District Department of the Environment

SUBJECT: Errata for the 2013 Stormwater Management Guidebook

Errata for the 2013 Stormwater Management Guidebook

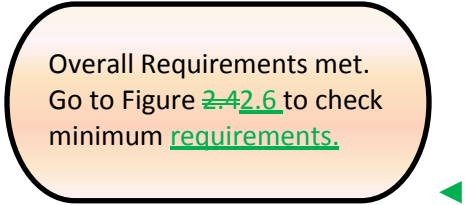
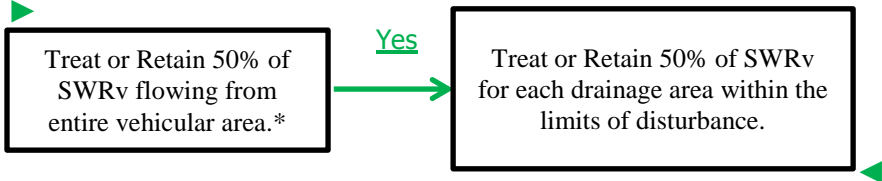
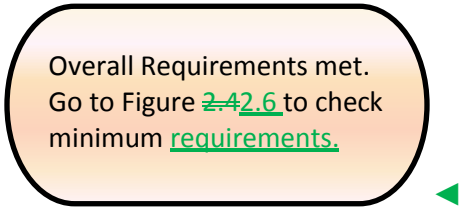
Description of Change	Page	Date Published	Type
In List of Figures, added new entries for Figures 5.3.1 and 5.3.2 (pages 282a and 282b, respectively), which were inadvertently omitted from the text. Also added an entry for Figure 5.3.3 (page 282c), which was developed to conform to the revised Declaration of Covenants template issued by the Real Estate Transactions Section of the D.C. Office of the Attorney General on April 23, 2014, which was updated to reflect the 2013 Rule on Stormwater Management and Soil Erosion and Sediment Control.	xix	05/01/2014	O
In List of Equations, added "a" after entry for Equation 3.5 (page 117) and added entries for new Equations 3.5b and 3.5c (page 117a), which were inadvertently omitted from the text.	xx	05/01/2014	O
In Figure 2.3 "Determining the regulatory event used to calculate the SWR _v ," revised the last object (shaded in blue) in the diagram to replace "Go to Figure 2.2 or Figure 2.3" with "Go to Figure 2.4 or Figure 2.5" to correct typographical errors.	15	05/01/2014	E

In Figure 2.4 "Determining if overall retention requirements have been met, outside the AWDZ," revised the oval-shaped object (shaded in orange) in the diagram to replace "Go to Figure 2.4..." with "Go to Figure 2.6..." to correct a typographical error.	16	05/01/2014	E
In Figure 2.5 "Determining if overall retention and water quality treatment requirements have been met, inside the AWDZ..." revised the oval-shaped object (shaded in orange) in the diagram to replace "Go to Figure 2.4..." with "Go to Figure 2.6..." and add "requirements." to correct typographical errors.	17	05/01/2014	E
In Figure 2.6 "Determining if minimum retention and water quality treatment requirements have been met," added a "yes" arrow that was inadvertently omitted between "Treat or Retain 50% of SWRZ flowing from entire vehicular area.*" and "Treat or Retain 50% of SWR _v for each drainage area within the limits of disturbance."	18	05/01/2014	O

In Figure 2.7 "Determining retention and water quality requirements for projects in the existing public right-of-way (PROW)," revised the oval-shaped object (shaded in orange at the top of the page) in the diagram to replace "Go to Figure 2.4..." with "Go to Figure 2.6..." and add "requirements." to correct typographical errors.	19	05/01/2014	E

Description of Change	Page	Date Published	Type
Chapter 2			
<p>Figure 2.3 Determining the regulatory event used to calculate the SWRv.</p>  <p>Remove “2.2” and “2.3” and replace with “2.4” and “2.5” to correct typographical errors.</p>	15	05/01/2014	E
<p>Figure 2.4 Determining if overall retention requirements have been met, outside the AWDZ.</p>  <p>Remove “2.4...” and replace with “2.6” to correct a typographical error.</p>	16	05/01/2014	E

Description of Change	Page	Date Published	Type
Chapter 2			
<p>Figure 2.5 Determining if overall retention and water quality treatment requirements have been met, inside the AWDZ for regulated activity governed by the Anacostia Waterfront Environmental Standards Act of 2012.</p>  <p>Remove “2.4” and replace with “2.6” and “add “requirements.” to correct typographical errors.</p>	17	05/01/2014	E
<p>Figure 2.6 Determining if minimum retention and water quality treatment requirements have been met.</p>  <p>Add a “yes” arrow from “Treat or Retain 50% of SWRZ flowing from entire vehicular area.*” to “Treat or Retain 50% of SWRv for each drainage area within the limits of disturbance.” to correct an inadvertent omission.</p>	18	05/01/2014	O

Description of Change	Page	Date Published	Type
Chapter 2 (continued)			
<p>Figure 2.7 Determining retention and water quality requirements for projects in the existing public right-of-way (PROW).</p>  <p>Remove “2.4” and replace with “2.6” and add “requirements.” to correct typographical errors.</p>	19	05/01/2014	E
<p>Section 2.8 Acceptable Urban BMP Options</p> <p>BMP Group 2 Rainwater Harvesting</p> <p>Rain water harvesting systems intercept, divert, store, and release rainfall for future use. Rainwater that falls on a rooftop is collected and conveyed into an above- or below-ground storage tank (also referred to as a cistern or rain tank), where it can be used for non-potable water uses and on-site stormwater disposal/infiltration. <u>The design includes:</u></p> <p><u>R-1 Rainwater harvesting for non-potable uses</u> ◀</p> <p>Add “The design includes: R-1 Rainwater harvesting for non-potable uses” to create consistent codes for incorporating the General Retention Compliance Calculator in DDOE’s new Stormwater BMP Tracking Database.</p>	24	05/01/2014	O
